SERVICE INFORMATION NO. SI 42-083

GARMIN – Service Alert No. 0824

NO.: 0823

SUBJECT: GDU 104X CRS/BARO Knob Interference

Figure 1

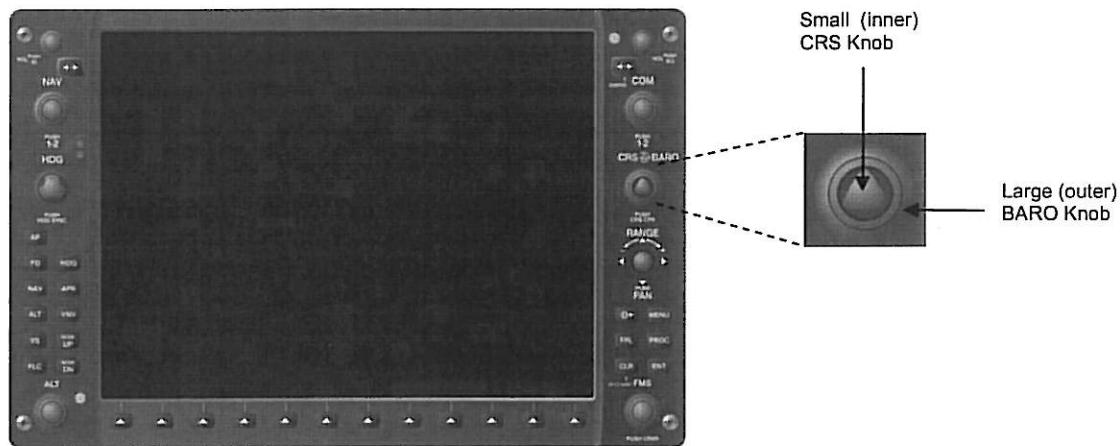
Garmin has identified an issue, whereby the large (outer) BARO knob and the small (inner) CRS knob may interfere with each other.

1. Apply power to the G1000/G900X/G950.
2. Press the CDI softkey on the Primary Flight Display(s) (PFD) to enter VOR mode on the HSI.
3. Rotate the large (outer) BARO knob (refer to Figure 1) a minimum of three complete revolutions in each direction while monitoring the Horizontal Situation Indicator/Digital Course Indicator (refer to Figure 2) on the PFD. If a change in the Horizontal Situation Indicator/Digital Course Indicator is produced while turning the BARO knob proceed to the Modification Instructions.

Figure 2

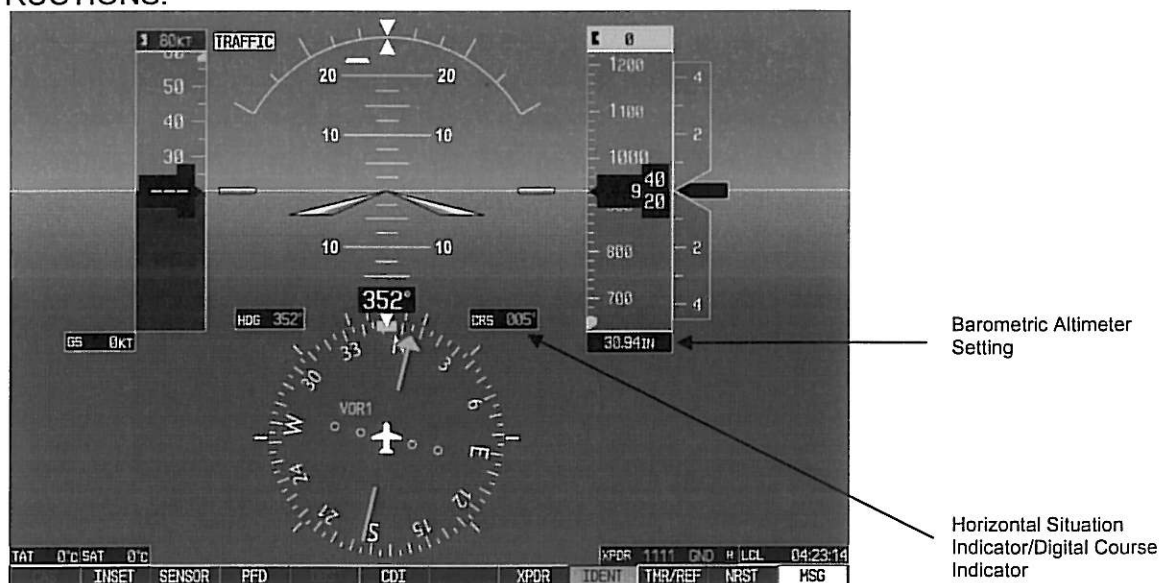
4. Rotate the small (inner) CRS knob (refer to Figure 1) a minimum of three complete revolutions in each direction while monitoring the Barometric Altimeter Setting (refer to Figure 2) on the PFD. If a change in the Barometric Altimeter Setting is produced while turning the CRS knob proceed to the Modification Instructions.
5. Repeat Steps 3 and 4 for each affected GDU.

Figure 3

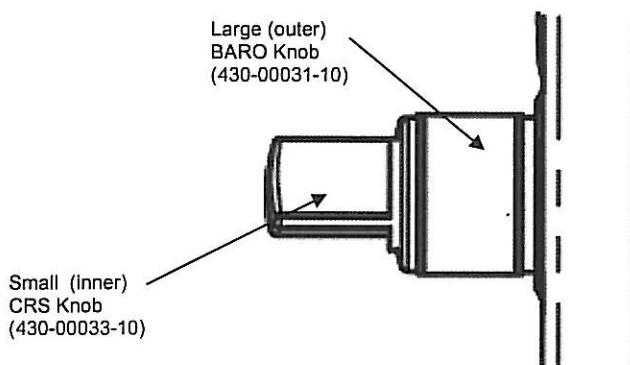
If CRS/BARO Knob interference is confirmed, perform the steps below to replace the CRS/BARO Knob. New knobs can be obtained through a Garmin Service Center or Aircraft OEM under Garmin part number K00-00446-00.

5. Grasp the large (outer) BARO knob (insuring proper orientation) and place it over the shaft.
6. Align the flat side of the knob insert with the flat side of the shaft.
7. Press down firmly to ensure knob is completely seated, refer to Figure 3.
8. Grasp the small (inner) CRS knob (insuring proper orientation) and place it over the shaft.
9. Align the flat side of the knob insert with the flat side of the shaft.
10. Press down firmly to ensure knob is completely seated, refer to Figure 3.
11. Perform the CRS/BARO Knob Interference Test (contained in the TESTING PROCEDURE section) again to confirm there is no interference.
12. Accomplish aircraft logbook entry to return aircraft to service in compliance with this service bulletin.
